Groundwater & Wastewater Services
Septic Project File & Data Review Worksheet

GWS File #: 6761B WASPS App #: 1378

GWS Septic System Design Review

RE: Request for an Improvement Permit for Lot 23 off of Sample Road.
MCHD File #6761B

ENCASEMENT PIPE DETAIL

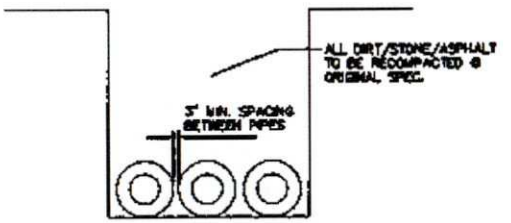
Mr. Fox-
Retreat at Latta specifically. I know NCDOT is much more reasonable, so I was wondering if we could do something a little less than welded steel pipe that may actually last longer. Welded Steel piping painted is $150K more than ductile iron with slip joints and tracer wires, and I cannot imagine there is a structural difference to the roadway. I would really like some help with that if you can.

Mr. Fox-
I was wondering if there is an alternate to the standard crossing detail or if we could propose an alternate to the welded steel pipe required by Huntersville. This is an extremely expensive option, and we would like to propose using ductile iron pipe with slip joints and different color tracer wires. We would still as-built everything the same, but the cost savings is tremendous, and the different color tracer wires would last longer than paint. Can you approve or is there someone else I'd need to go through?
Thanks,
Tom

Upon your request, you may use slip joint ductile iron encasement pipe in lieu of the welded steel pipe as indicated on the Encasement Detail for the low pressure sewer crossings at the Retreat at Latta. This change is being made due to the fact that ductile iron will provide adequate strength for the crossing as well as provide water tight seals at the joints. Please note however, this is the only change being made to that detail. Specified lengths, depths, and sizes shall still be in compliance with the detail.
